SBN-370  
T.F. B7.1.2

Subject: Revised Response to RAIs 440.22, 440.45, and 440.52

REPLY TO NRC REVIEWER COMMENTS  
SEABROOK/SUMP

FIGURE 1 ARL VORTEX CLASSIFICATION CHART

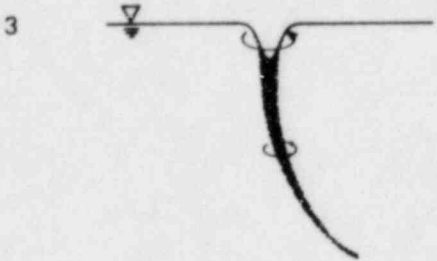
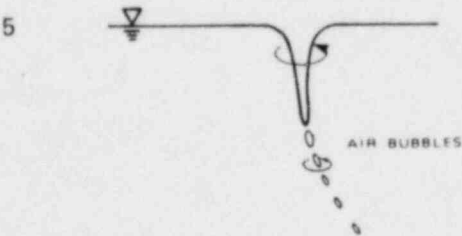
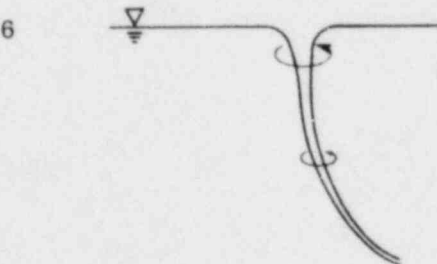
The staff will require verification that no vortexing tendencies exist in the recirculation sump. Discuss the full scale preoperational tests which will show that under prototypical post-LOCA conditions, no adverse flow conditions will occur which could degrade ECCS pump performance. In lieu of full scale in plant tests, a scale model sump test may be acceptable to the staff. If you chose to conduct a scale model test, provide details of the test program. Include information of the model size, scaling principles utilized, comparison of model parameters to expected post-LOCA conditions, and a discussion on how all possible flow conditions and screen blockages will be considered in the model tests. The applicant should be advised that due to scaling problems, the staff will require that model test indicate considerable margin is available in respect to vortexing tendencies. Rotational flow patterns and surface dimples which might be acceptable in full scale tests, may not be acceptable in a model program.

The ARL Classification Chart for Free Surface Vortex Activity, Figure 1, attempts to evaluate sump flow patterns over a wide range of conditions, and

the defined flow patterns are not limited to actual vortex action. In the classification, vortex types 1 and 2 are not true vortices since they are limited to the surface motion only and do not interact with the suction inlet directly. The first true coherent vortex motion is the type 3, vortex which is a dye core occurring over the entire depth of the water column and usually entering the suction inlet.

In the Seabrook study, most vortex activity was limited to types 1 and 2, while the maximum vortex observed in only a few cases was a type 3 dye core vortex, which was noted to be "very intermittent and weak" or "surface activity only". In two previous studies (5, 7), a type 3 dye core vortex was noted in the final design. In both previous cases, as in the Seabrook study, the vortex was transient and occurred for only a few of the conditions tested. All other studies have had type 2 vortices. The NRC reviewers have not found the performance of any of the sumps studied to be unacceptable.
